HISTORIC AND DESIGN REVIEW COMMISSION

August 21, 2019

HDRC CASE NO: 2019-433
ADDRESS: 233 GREENLAWN
LEGAL DESCRIPTION: NCB 8417 BLK 2 LOT 46
ZONING: R-5,H
CITY COUNCIL DIST.: 1
DISTRICT: Greenlawn Estates
APPLICANT: ARMENDARIZ RUBEN P &
OWNER: ARMENDARIZ RUBEN P &
TYPE OF WORK: Window replacement
APPLICATION RECEIVED: July 10, 2019
60-DAY REVIEW: September 8, 2019
CASE MANAGER: Stephanie Phillips
REQUEST:

The applicant is requesting a Certificate of Appropriateness for approval to replace six (6) wood windows (Window #13, 14, 15, 16, 17, and 18, per the submitted window schedule) with aluminum-clad windows on the primary structure.

233 Greenlawn

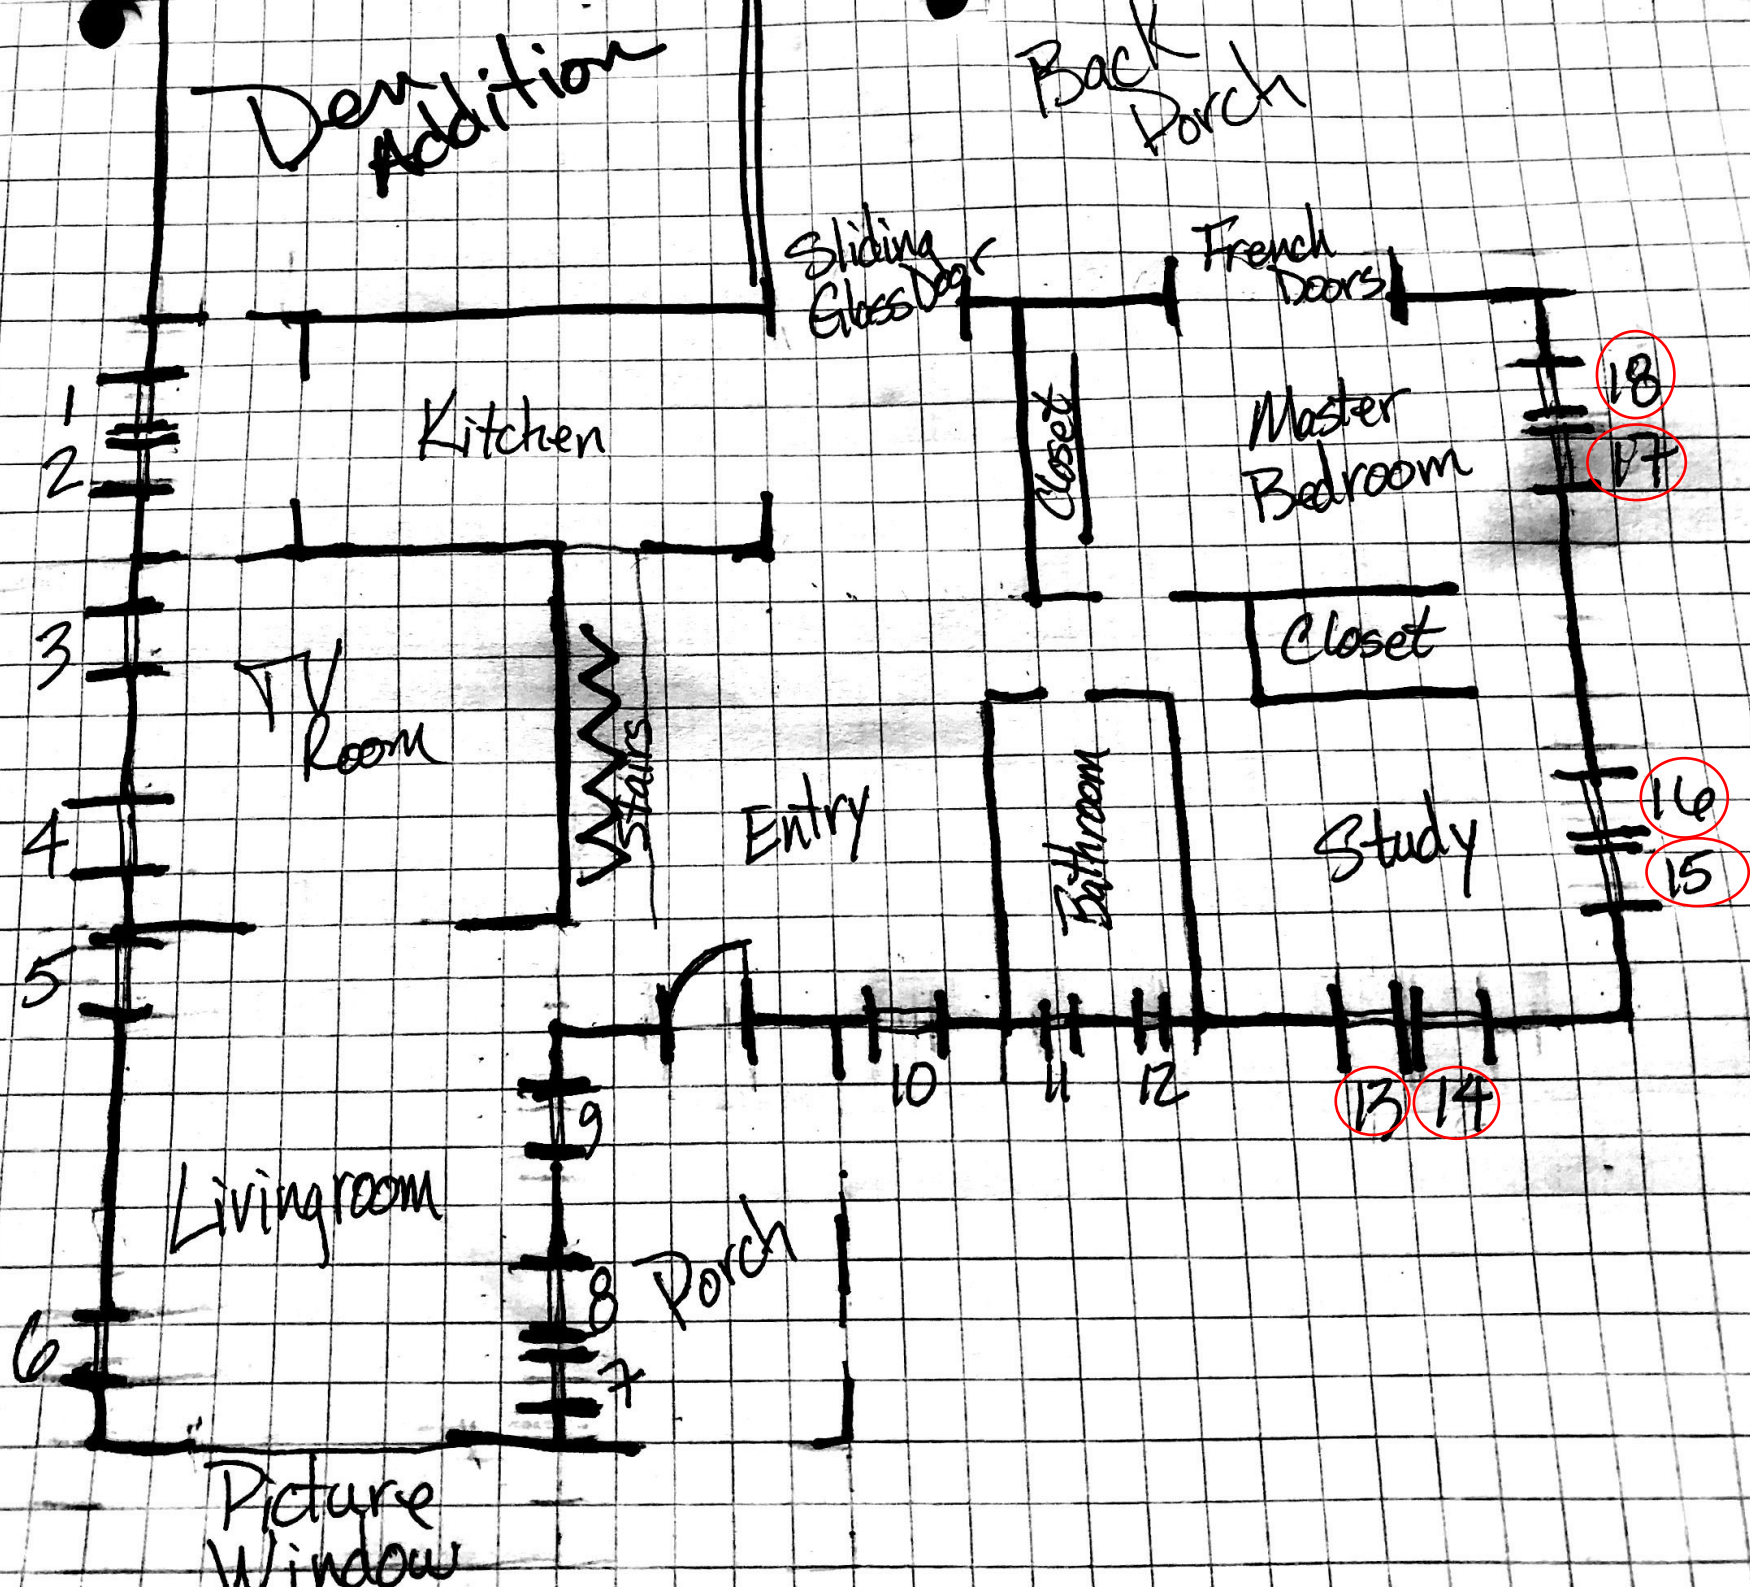
The applicant has proposed to replace six (6) wood windows (Window #13, 14, 15, 16, 17, and 18, per the submitted window schedule) with aluminum-clad windows on the primary structure. Six wood windows (Windows #7, 8, 9, 10, 11 and 12, per the submitted window schedule) have already been replaced with aluminum-clad windows without a Certificate of Appropriateness.

Windows 13 & 14

Window 15

Windows 15 and 16

Windows 17 and 18

Staff does not recommend approval of the window replacements based on findings a and b.
